6/24/14	Added New Sheet.
DATE	REVISION
STATE OF HAWAII DEPARTMENT OF TRANSPORTATION HIGHWAYS DIVISION	
WATER POLLUTION & EROSION CONTROL NOTES	
HALEAKALA HIGHWAY INTERSECTION IMPROVEMENTS AT KULA HIGHWAY Project No. 37C-01-14	
Date: June, 2014	
SHEET No. 1 OF 3 SHEETS

6/24/14	Added Notes.
DATE	REVISION
STATE OF HAWAII DEPARTMENT OF TRANSPORTATION HIGHWAYS DIVISION	
TYPICAL SECTIONS & DETAILS	
HALEAKALA HIGHWAY INTERSECTION	
IMPROVEMENTS AT KULA HIGHWAY	
Project No. 37C-01-14	
Scale: As Shown	Date: April, 2014
SHEET No. 1 OF 3 SHEETS

DEMOLITION PLAN

**HALEAKALA HIGHWAY INTERSECTION
IMPROVEMENTS AT KULA HIGHWAY**

CURB RAMP PLANS
HALEAKALA HIGHWAY INTERSECTION
IMPROVEMENTS AT KULA HIGHWAY
Project No. 37C-01-14
Scale: 1"= 5' Date: April, 2014

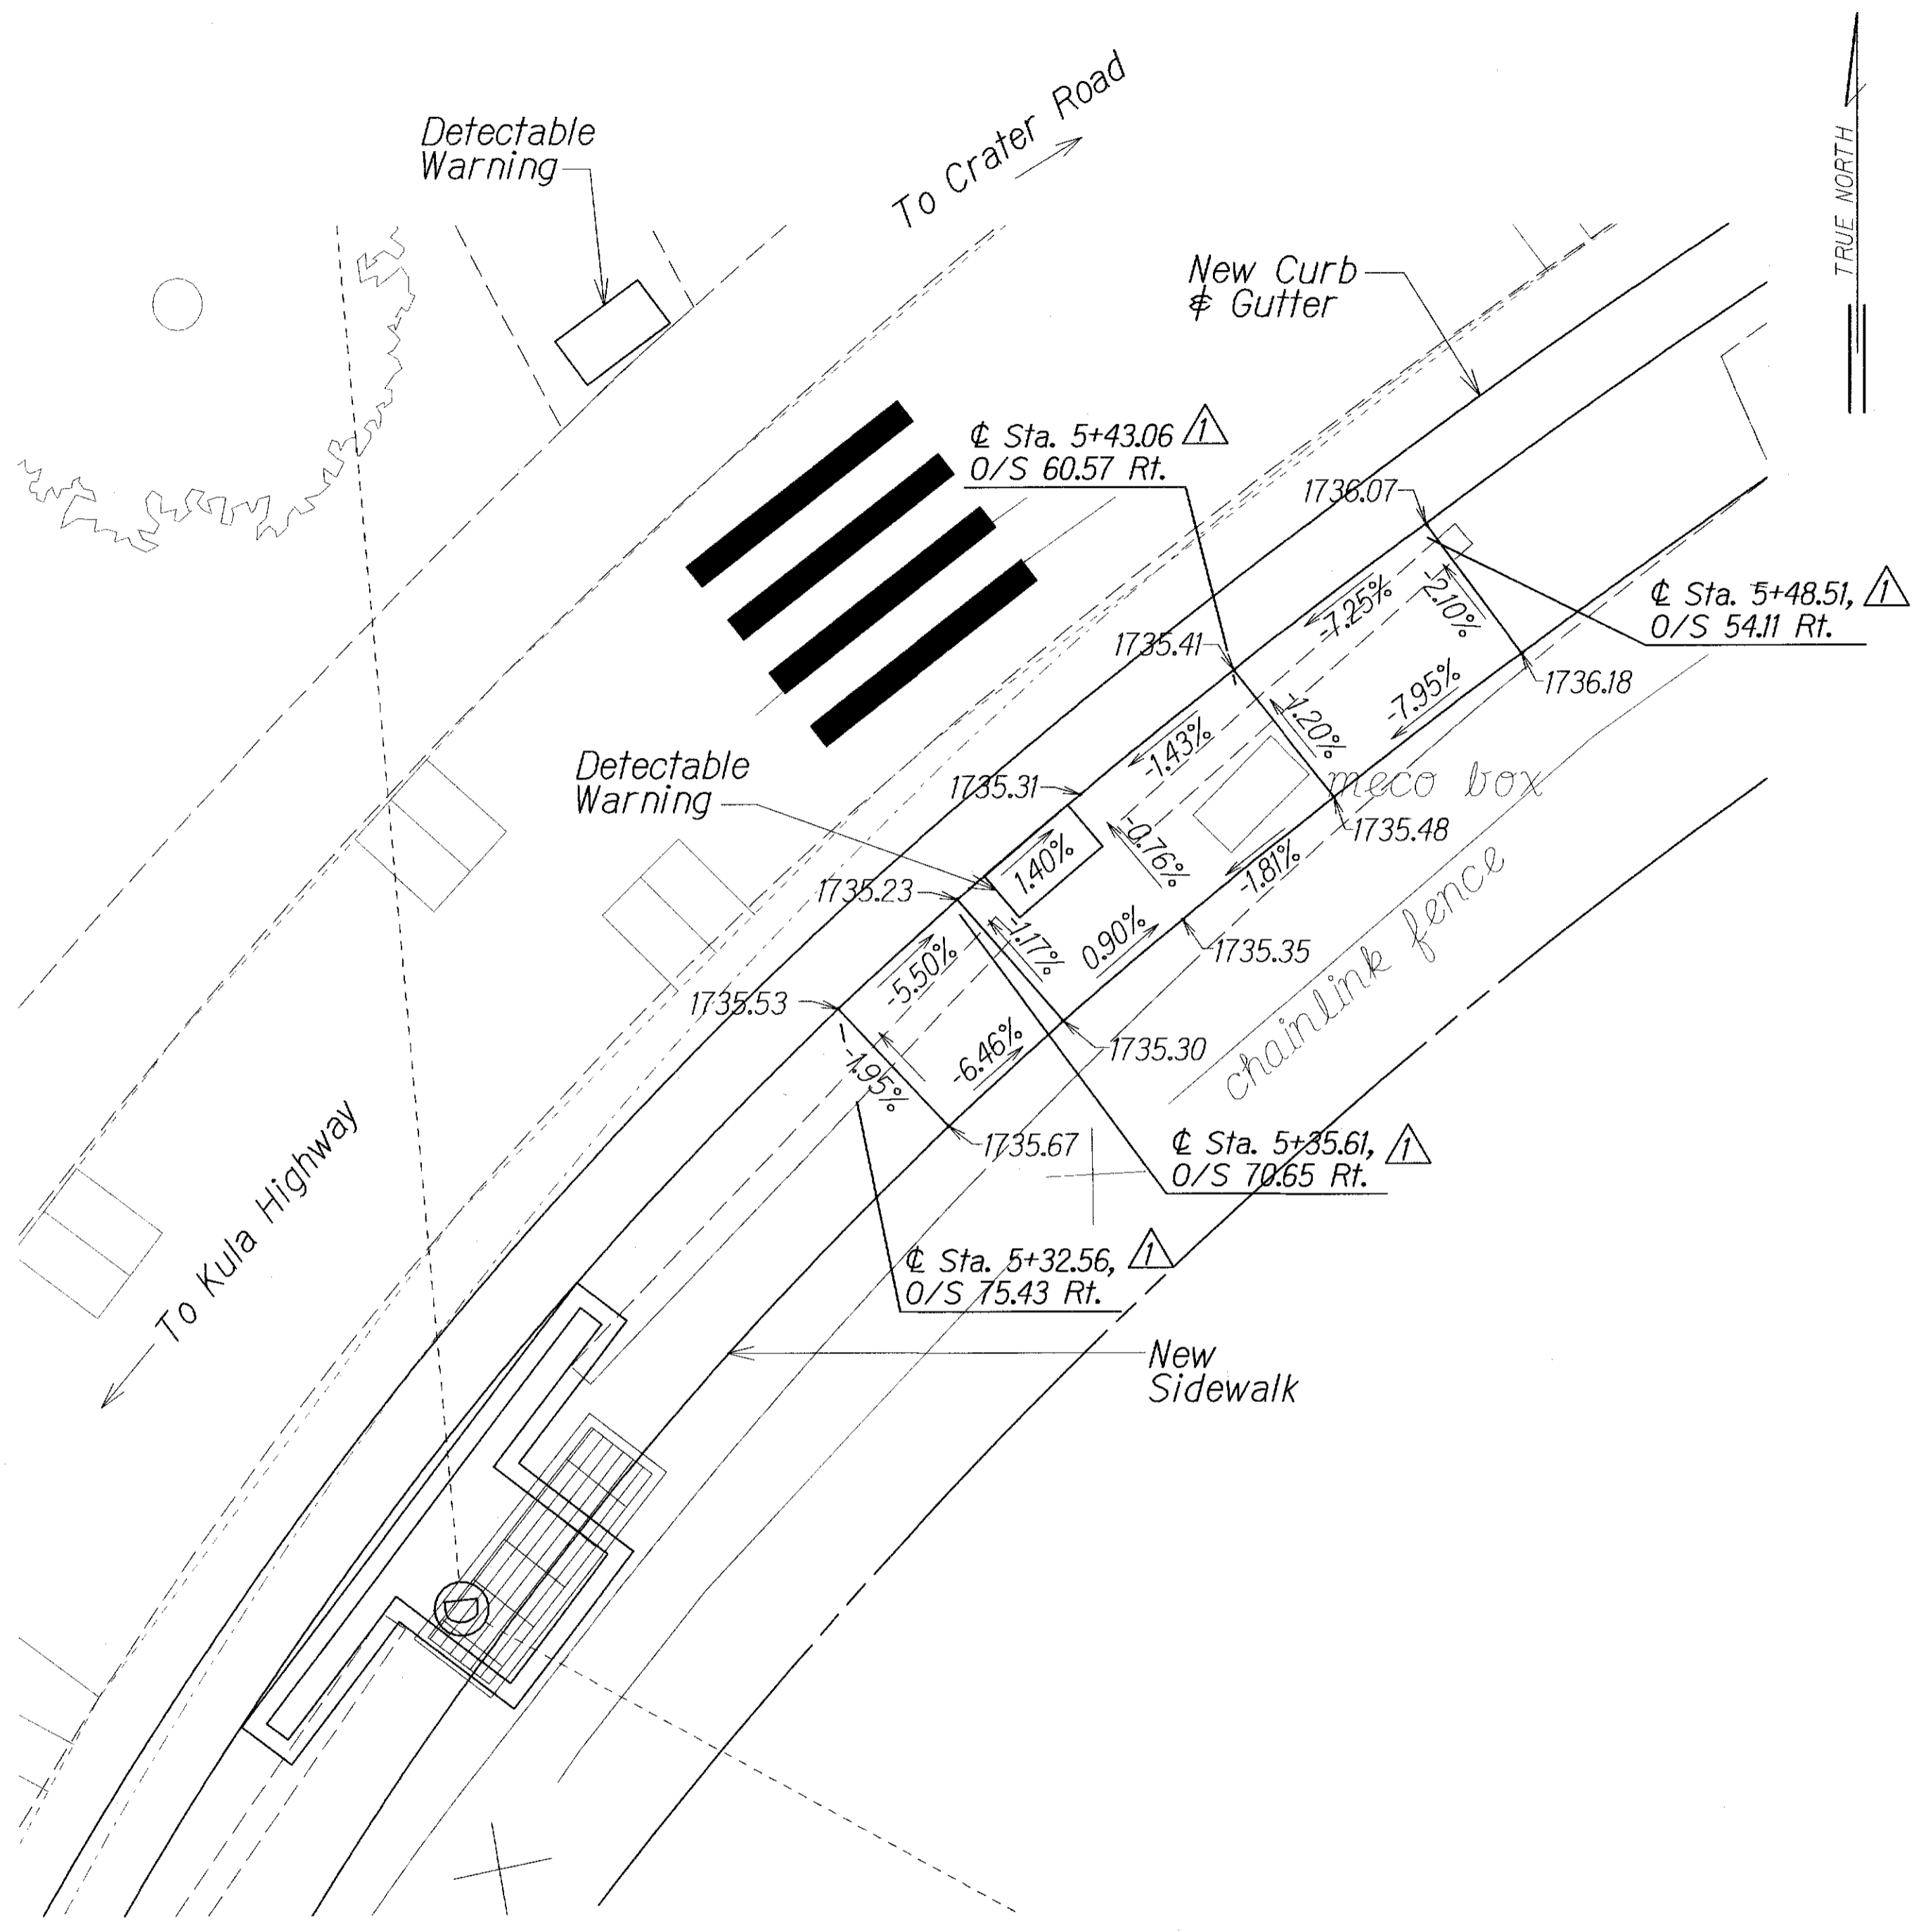
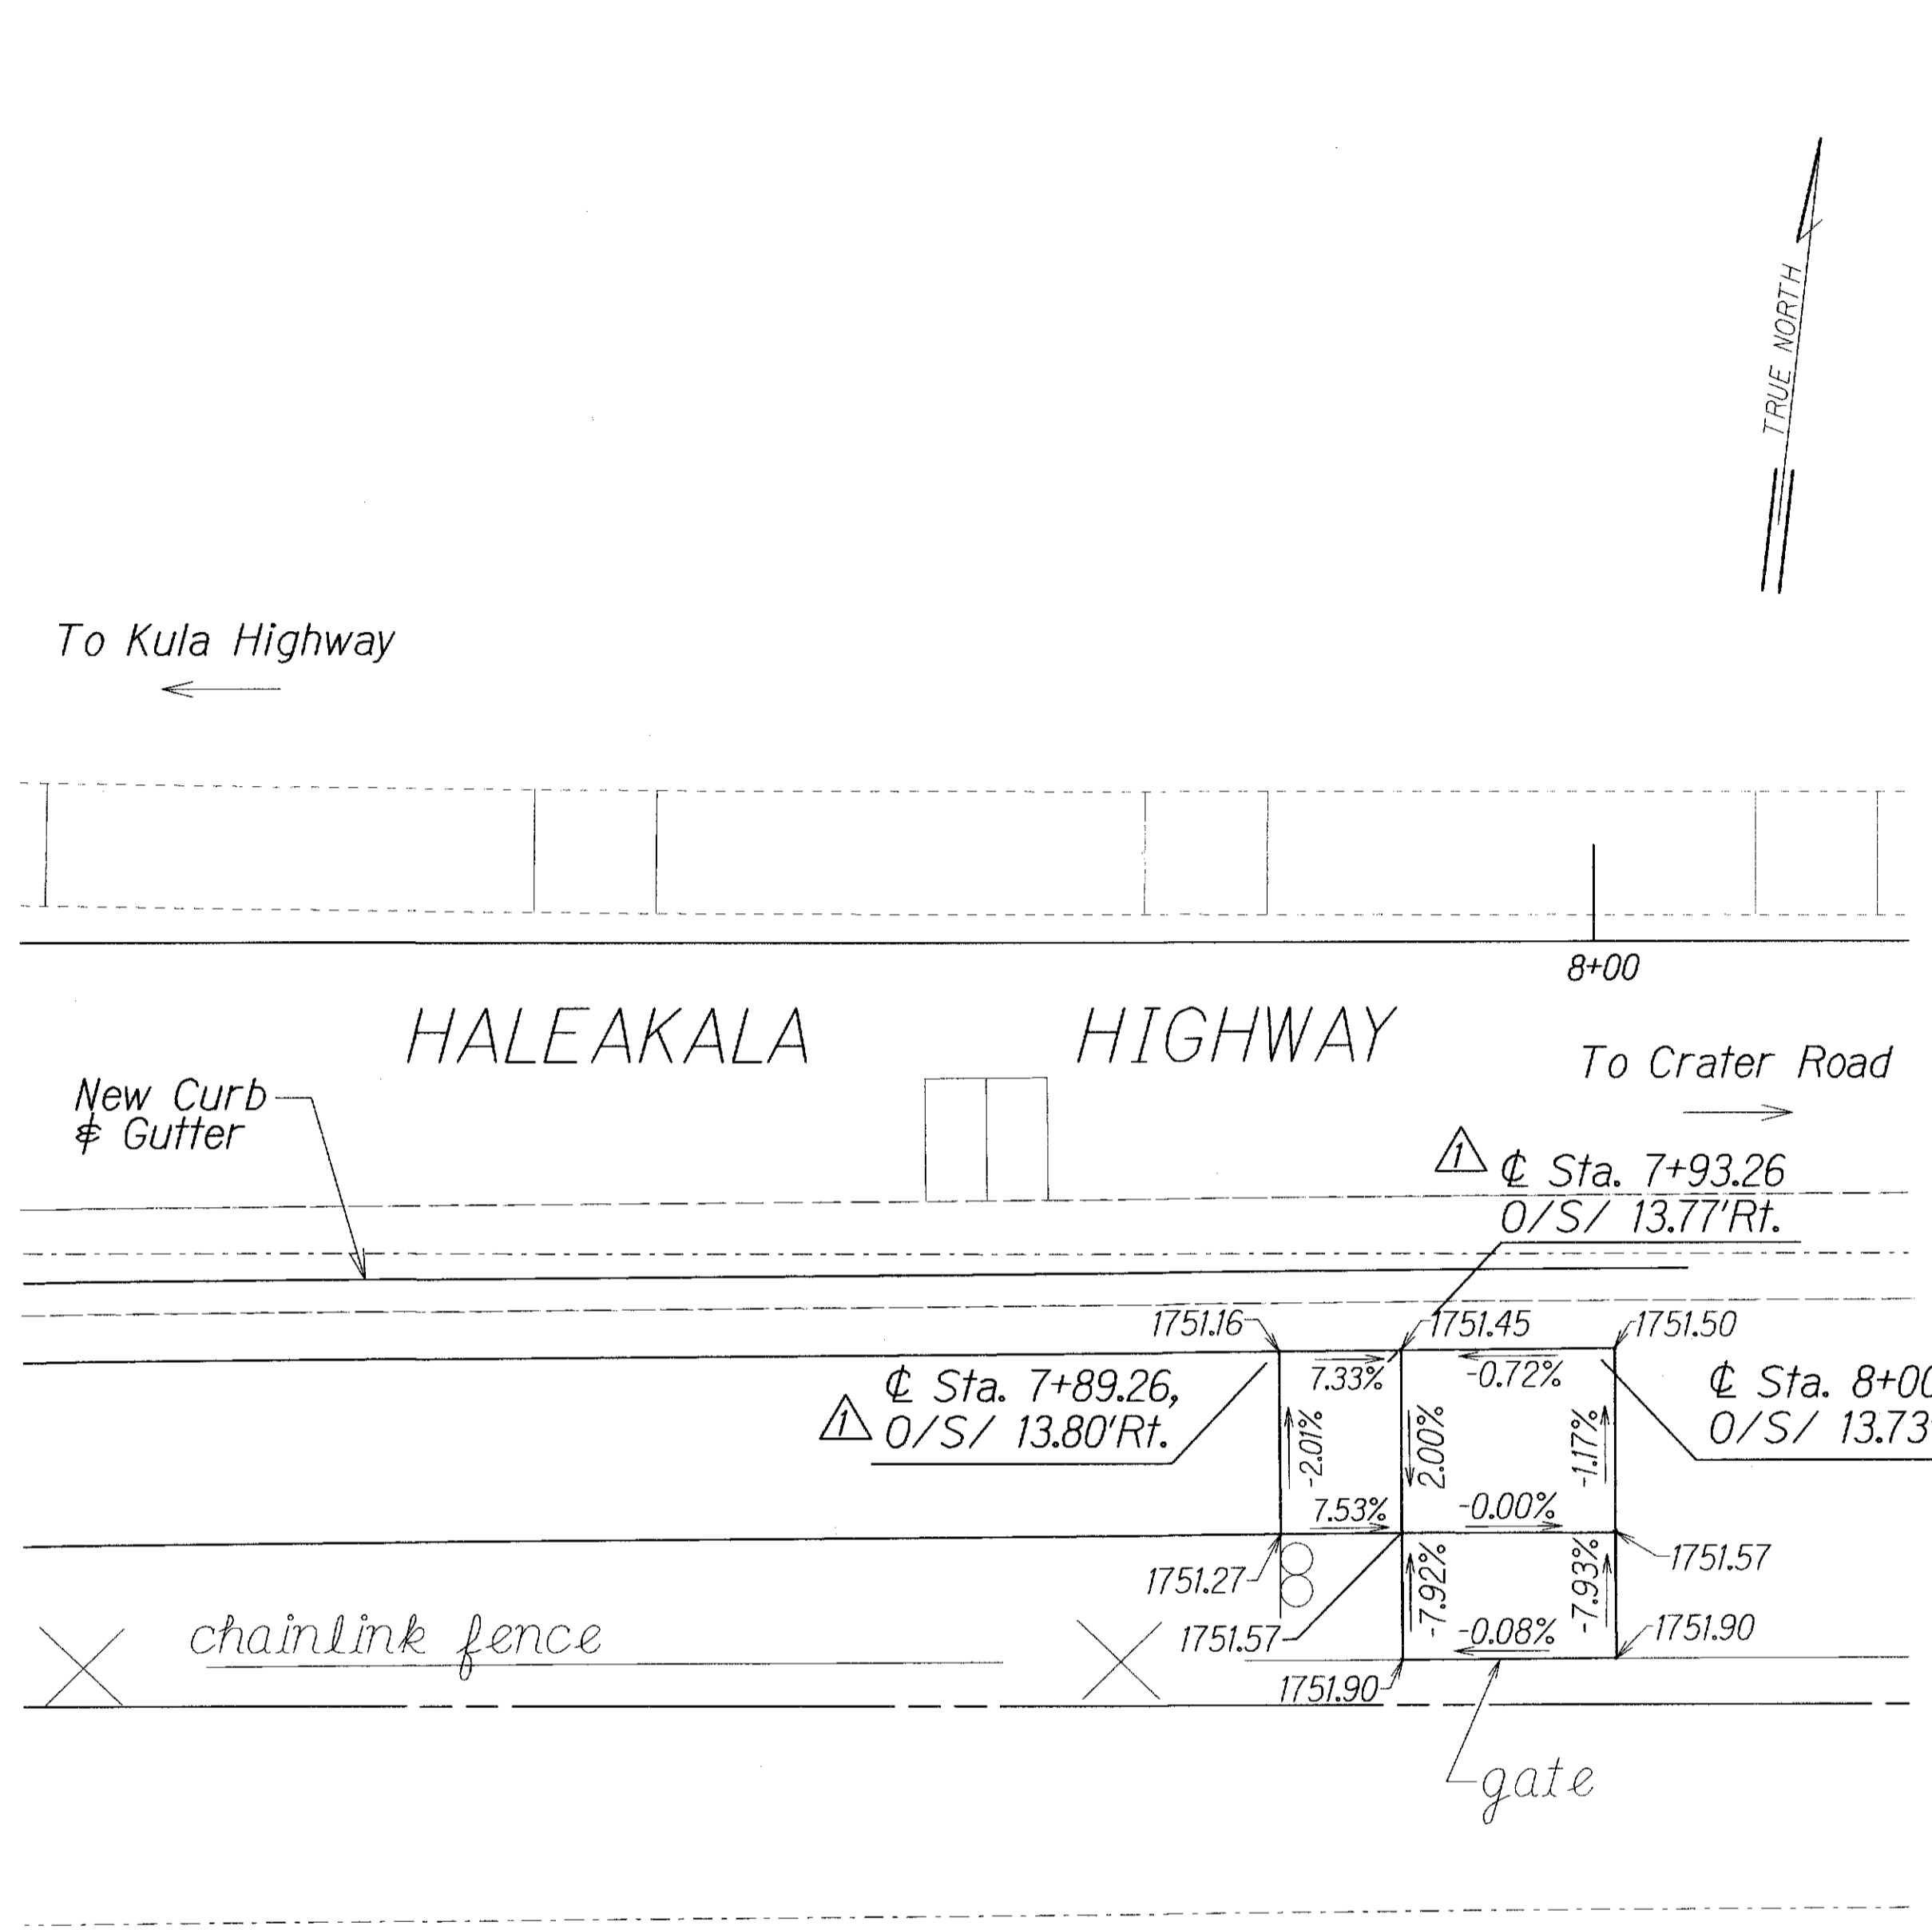
6/24/14 **Added Station Numbers and Offsets.**
